SERVICE BULLETIN

model number 4240	bulletin number M-4240-A
for serial numbers Below 100001	
subject Elimination of AC Line Switching Transients	
engineering approval <i>E. Leggett</i> <i>(Signature)</i>	date 10-7-74

Fig. 1A

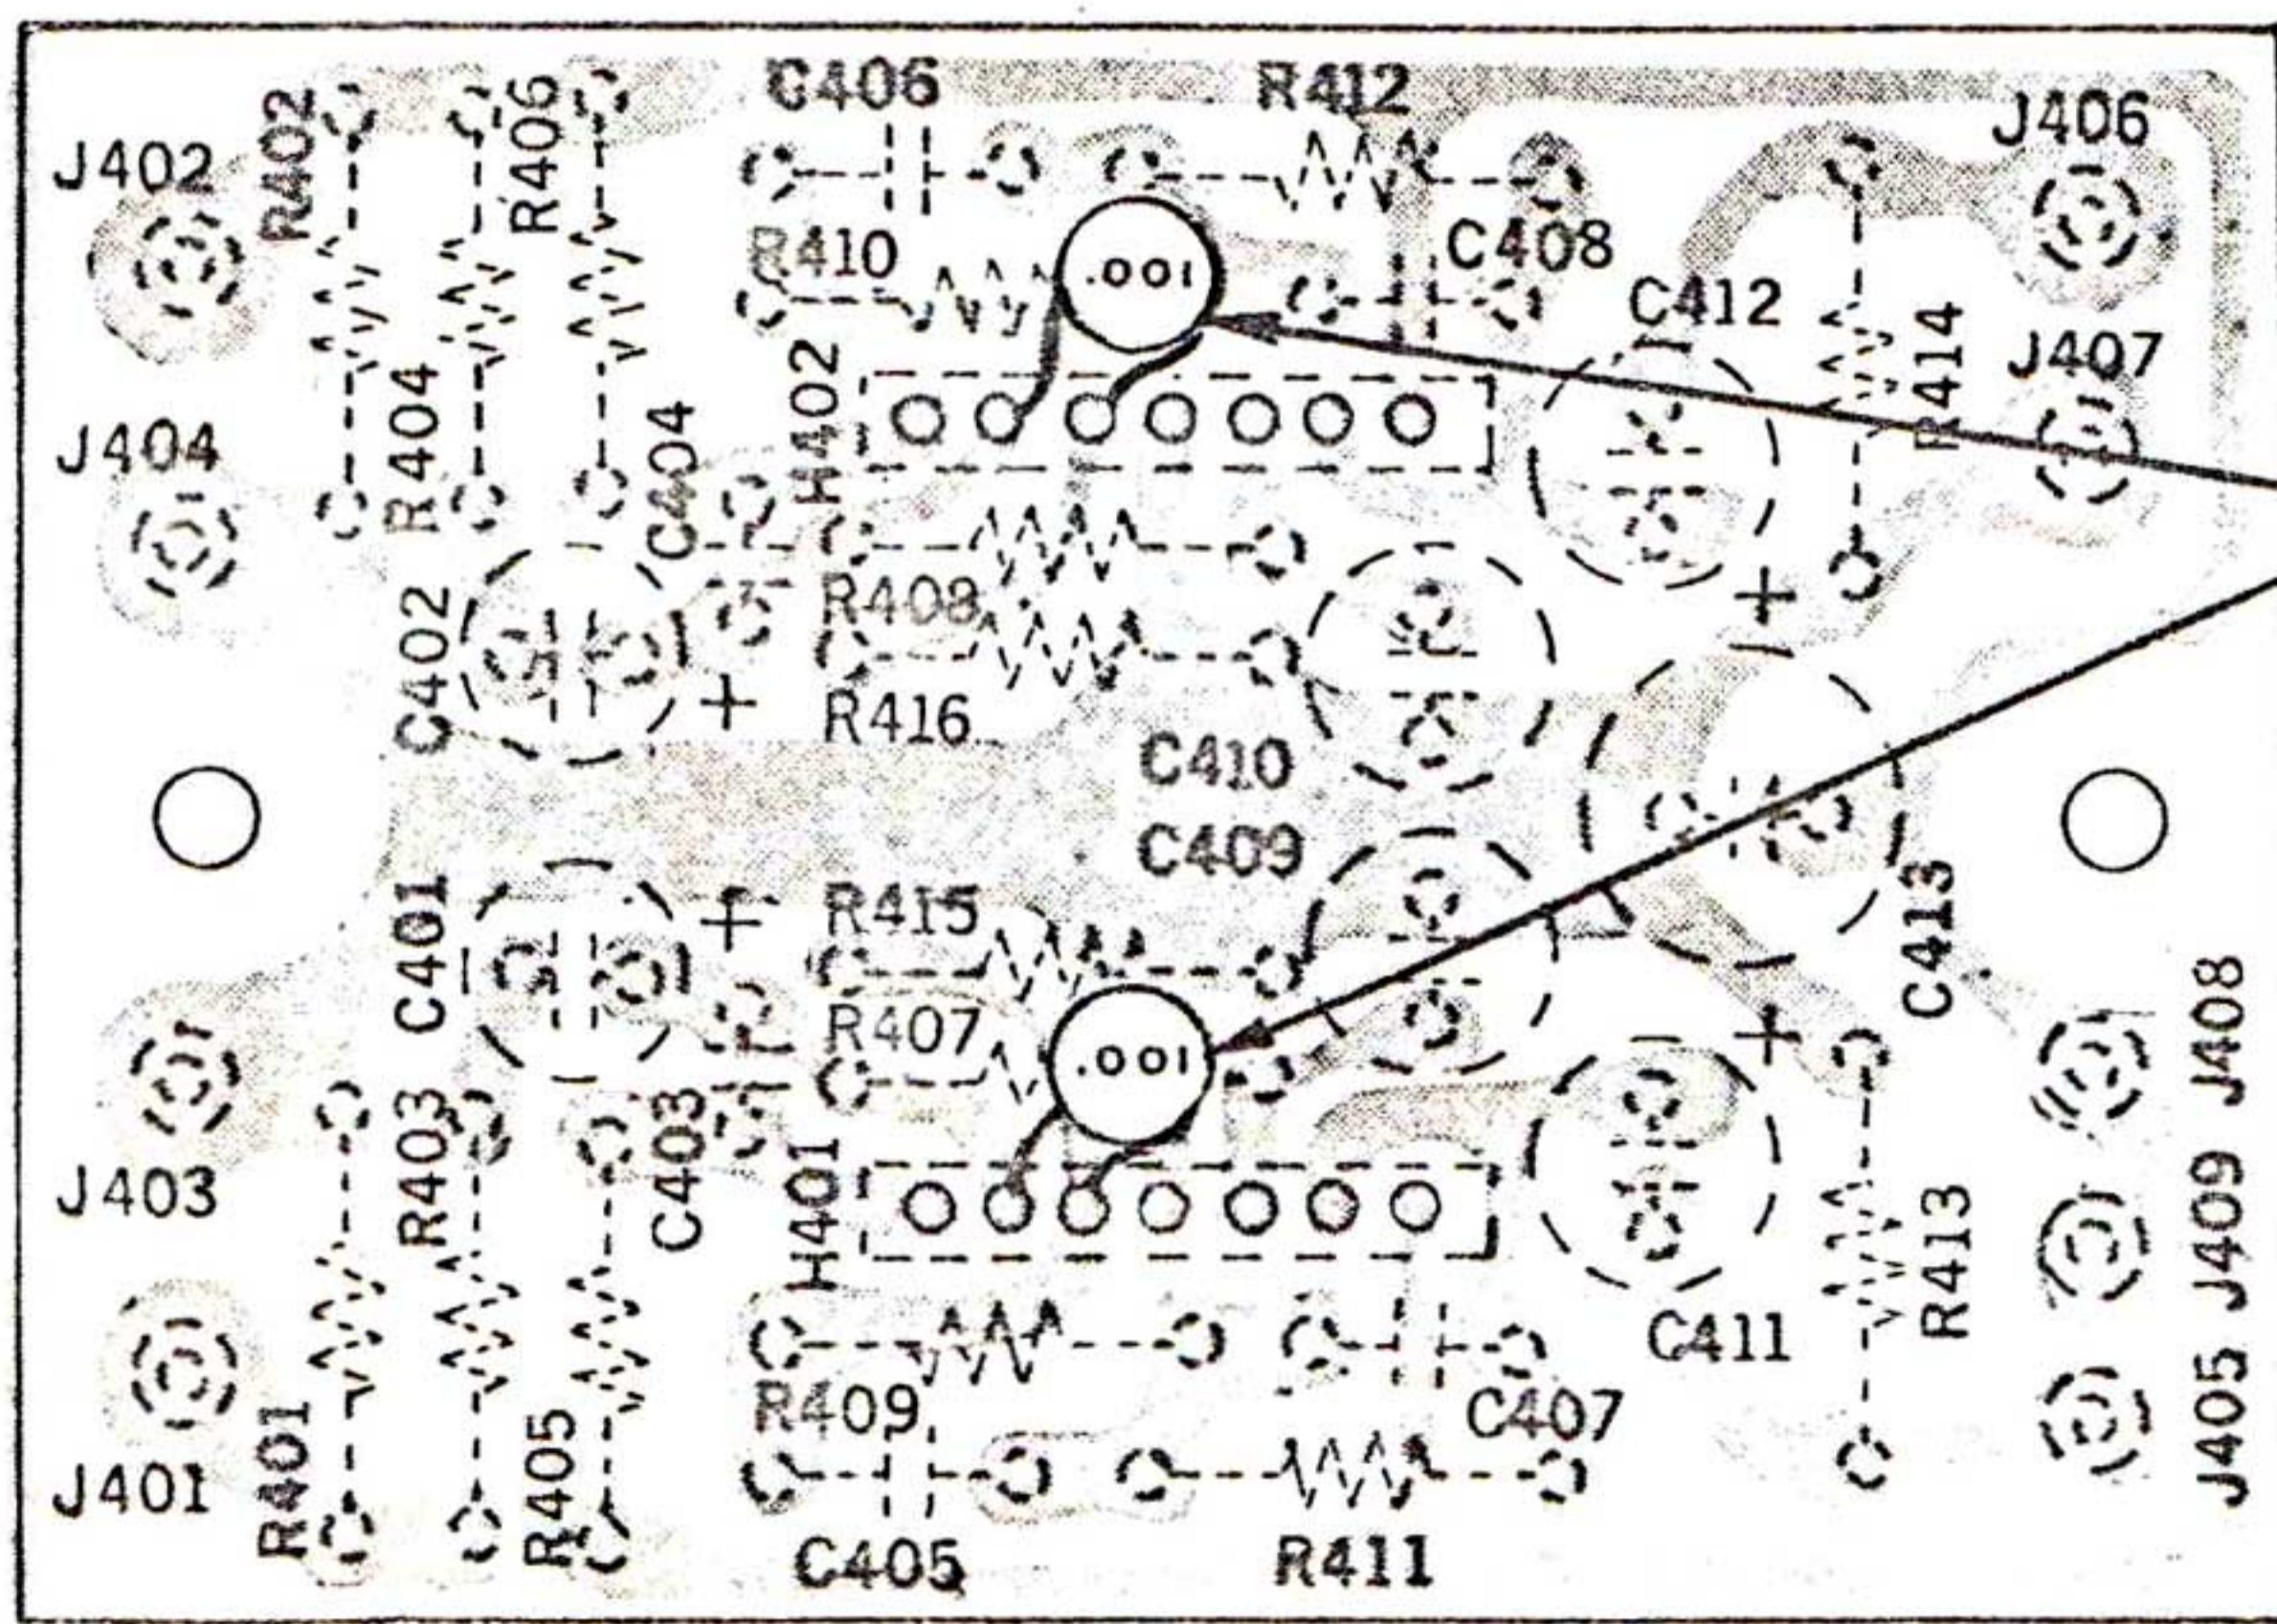
1. Connect a 1000pF ceramic disc capacitor between pins number 2 and 3 of IC H401 and IC H402 on the foil side of the Phone Preamp Board, (See figures 1A and 1B).

Fig. 1B

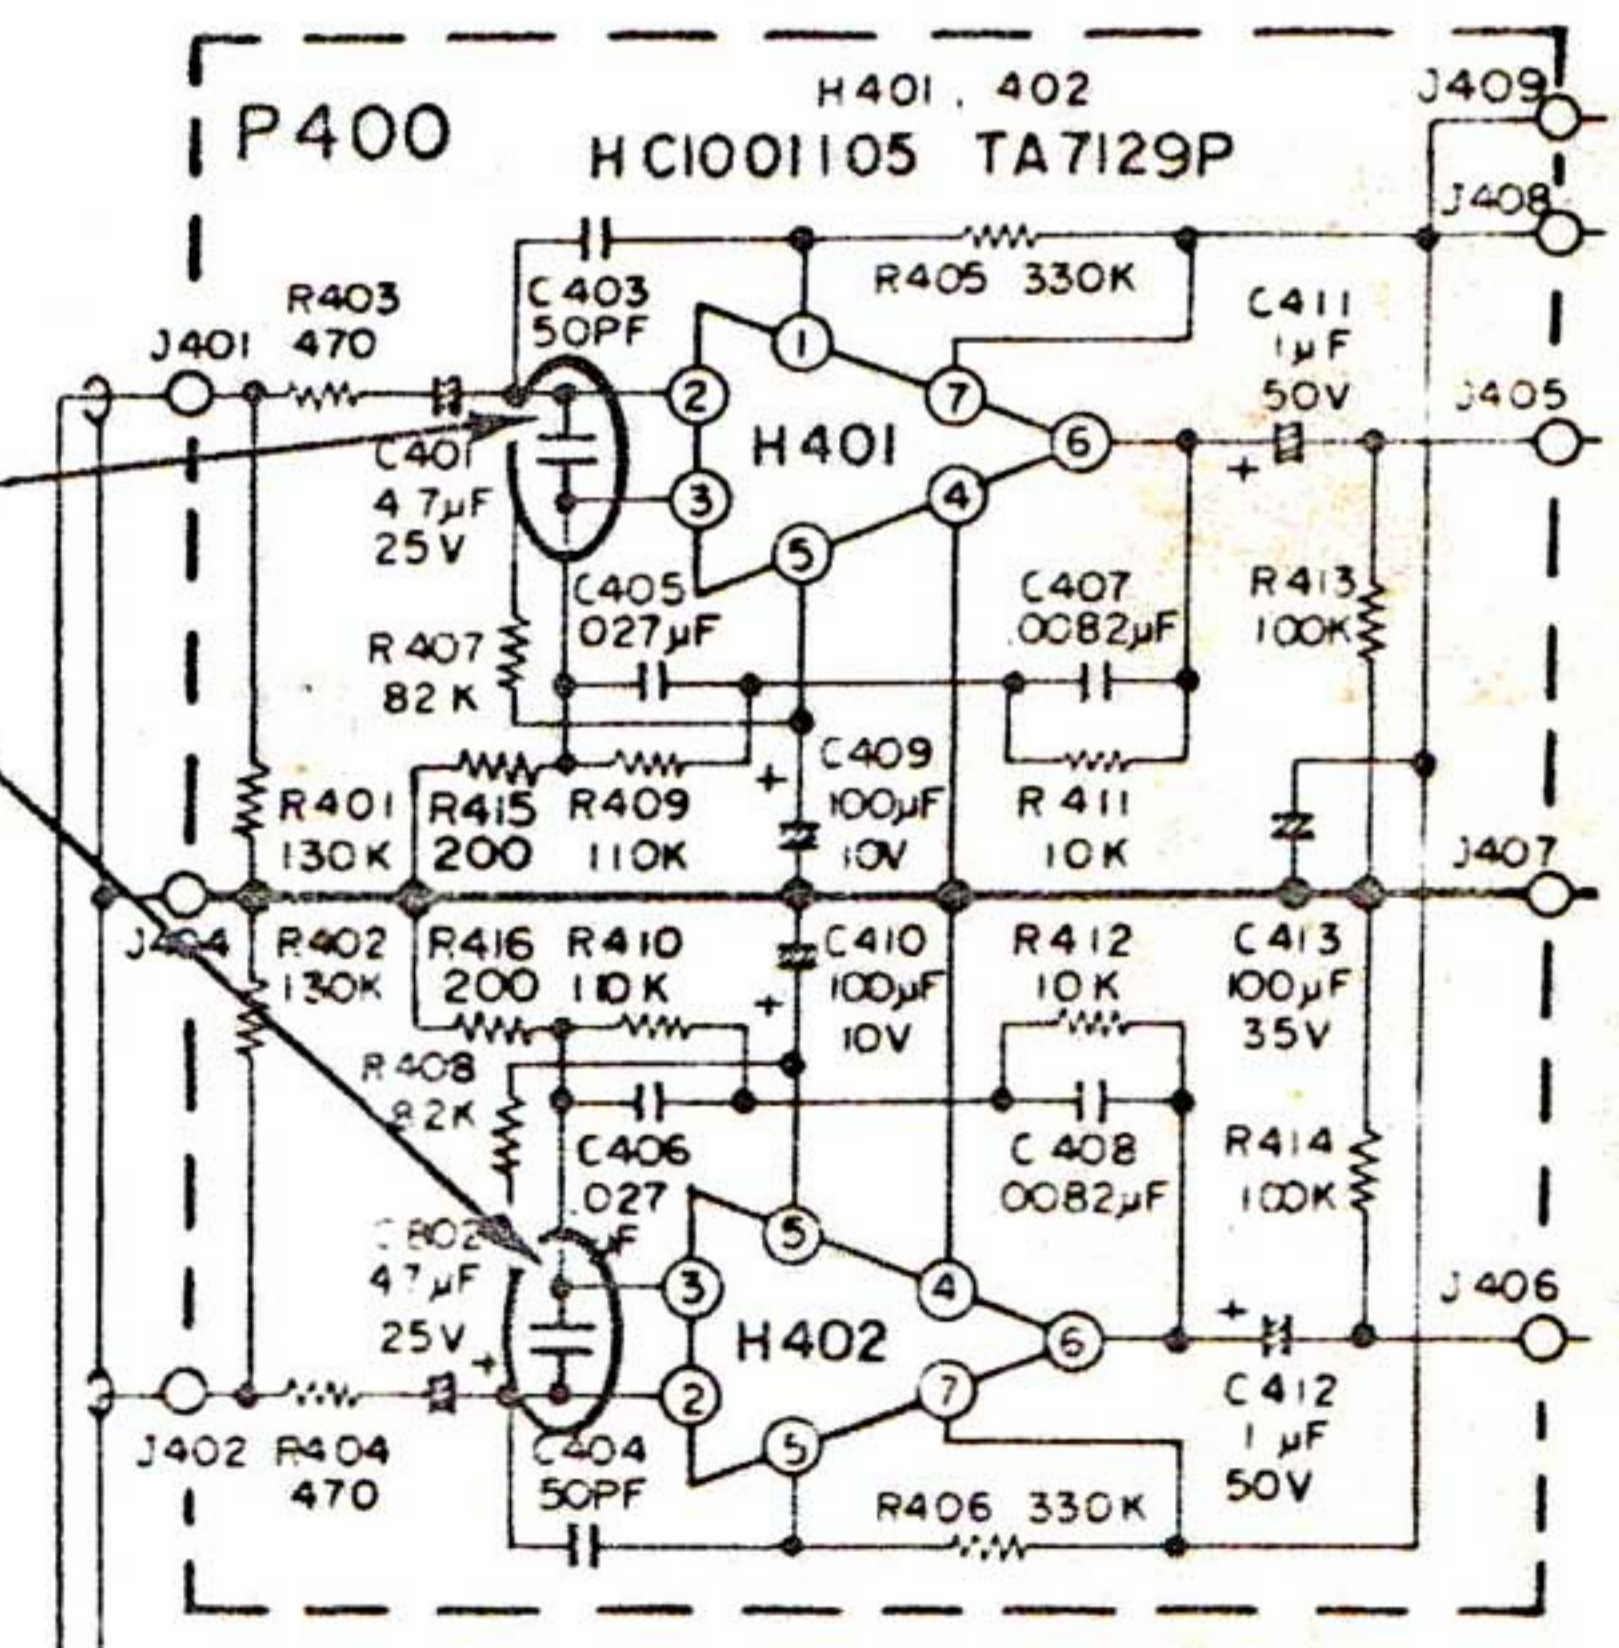
ADD
1000 pF, 50 VDC CAPACITOR
314-1028-000

REAR VIEW: FRONT/REAR CHANNEL JACKS

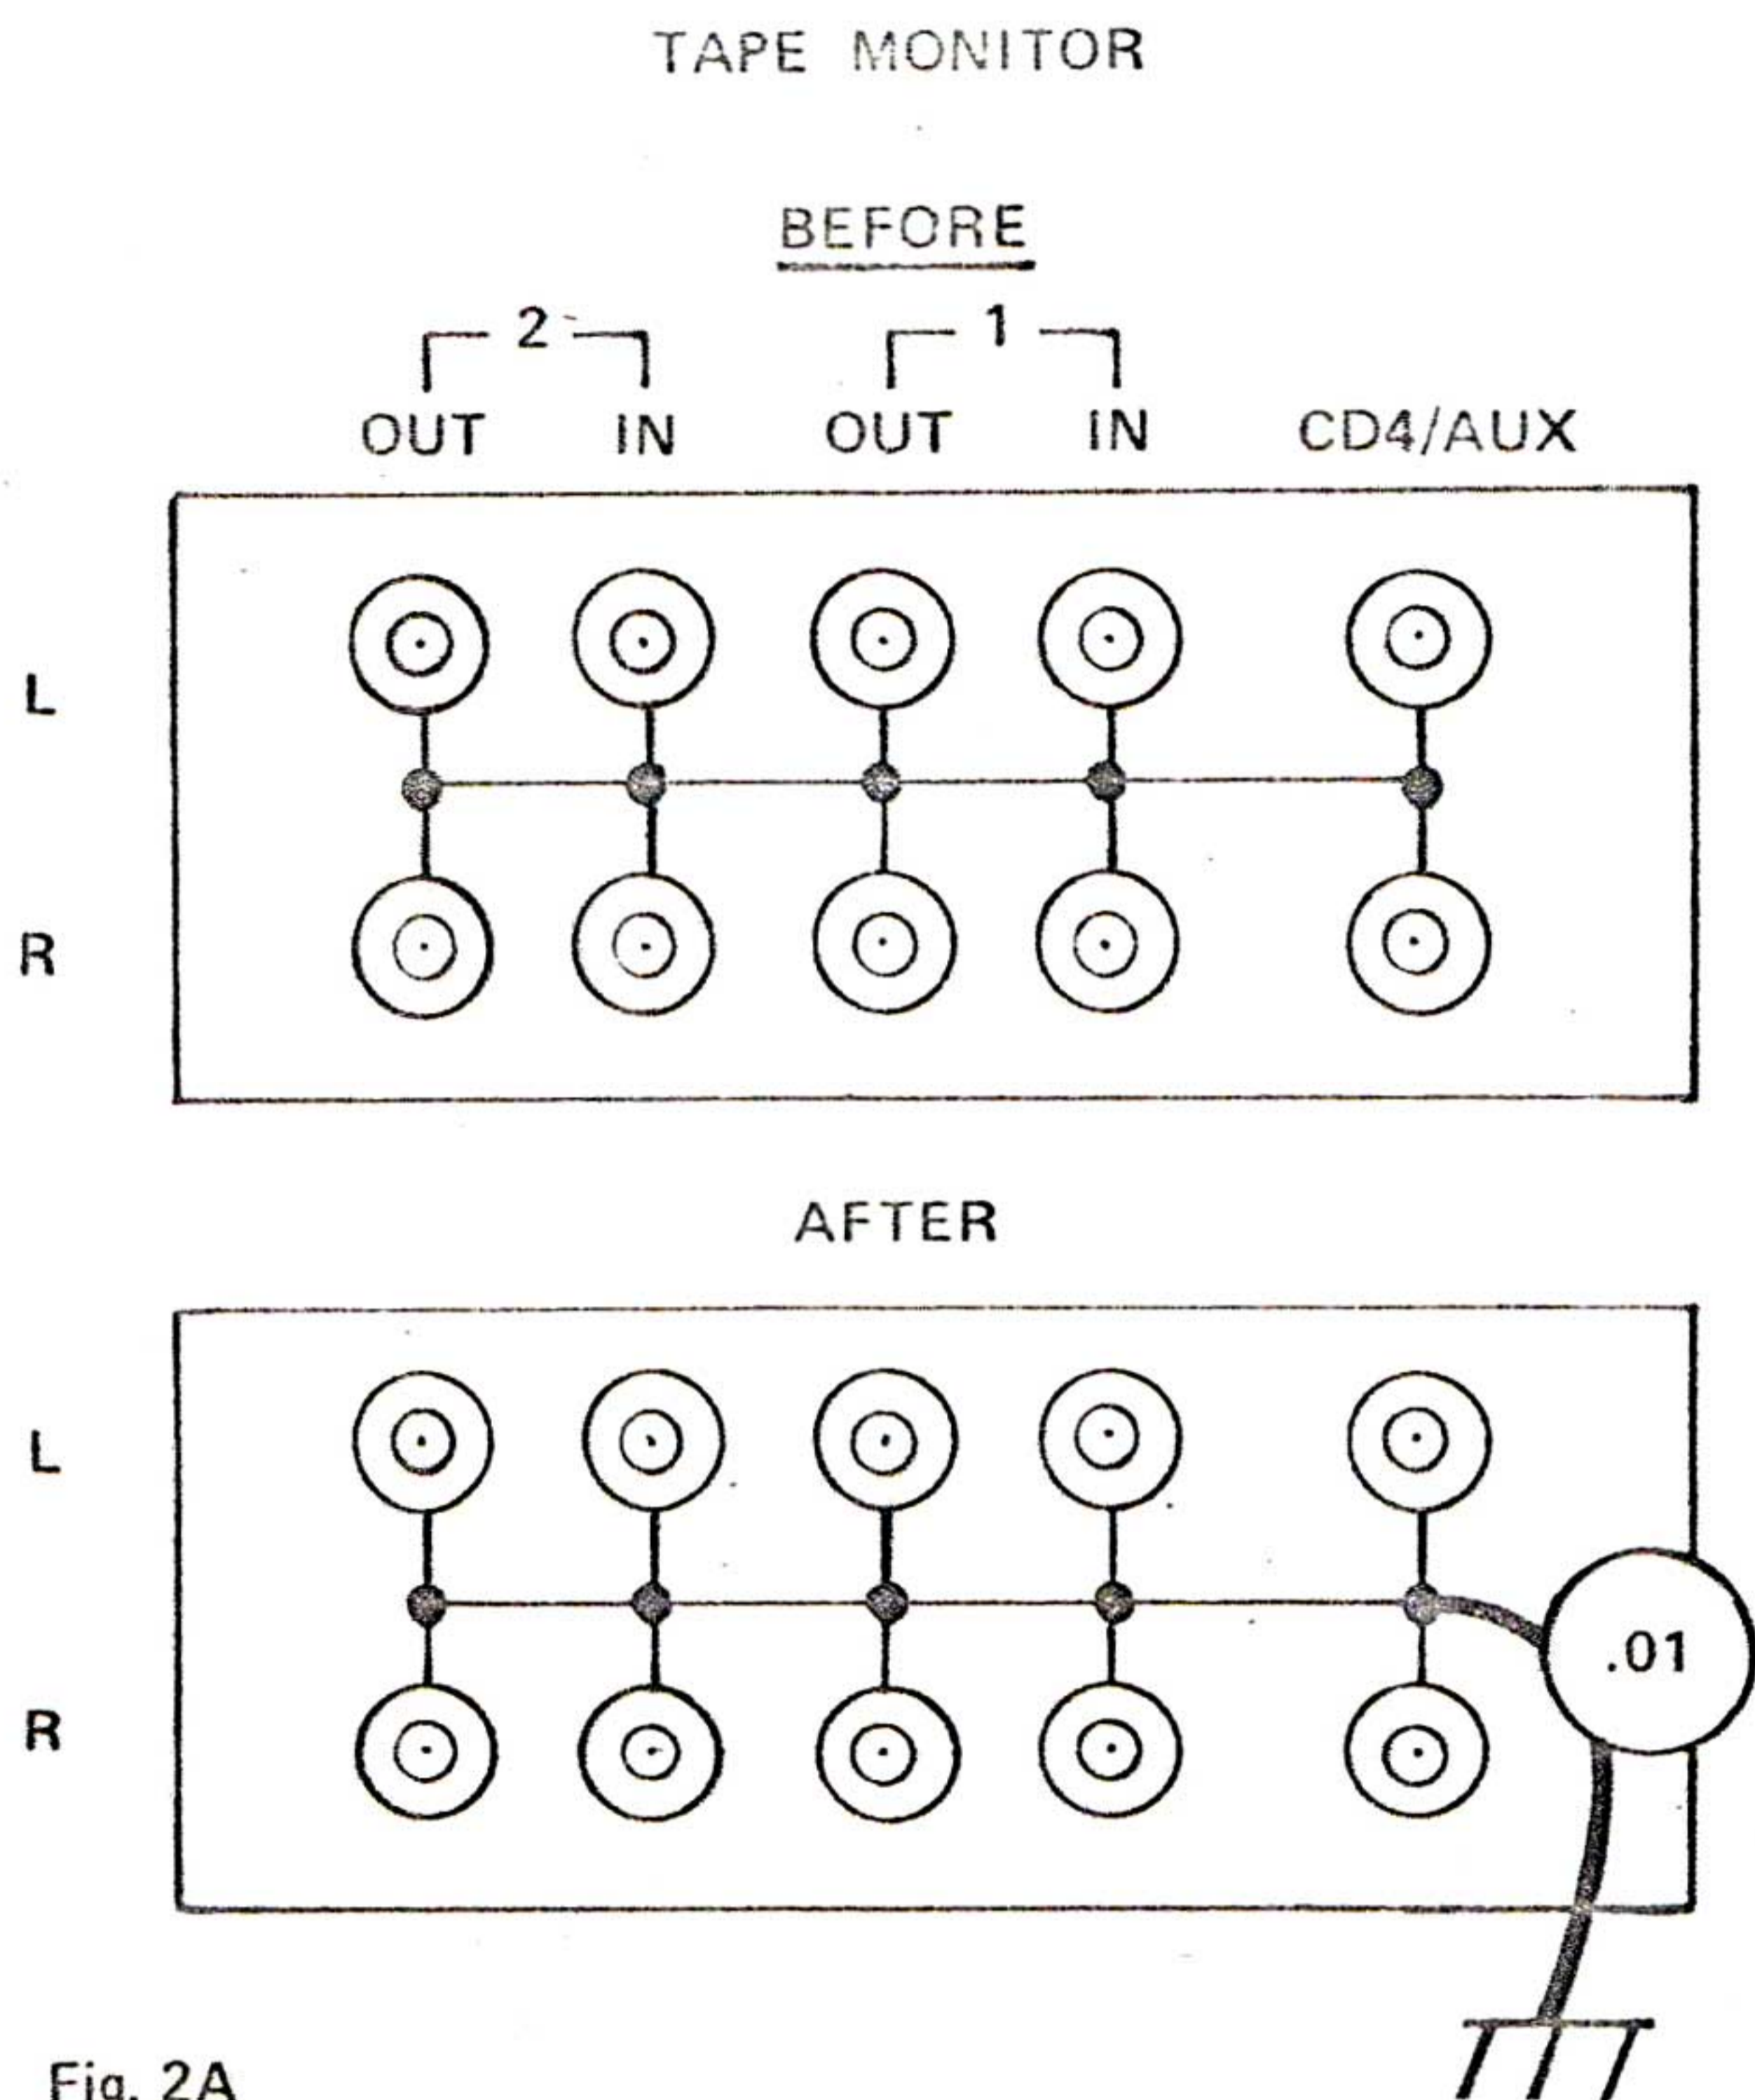
2. Connect a 0.01 μ F ceramic disc capacitor between chassis and common grounding bus of front channel AUX, TAPE IN and TAPE OUT jacks. Also, connect another .01 μ F capacitor between chassis and common grounding bus of rear channel AUX, TAPE IN and TAPE OUT jacks, (See Figures 2A and 2B).

Note: Keep capacitor leads as short as possible to avoid lead inductance which would reduce their effectiveness.
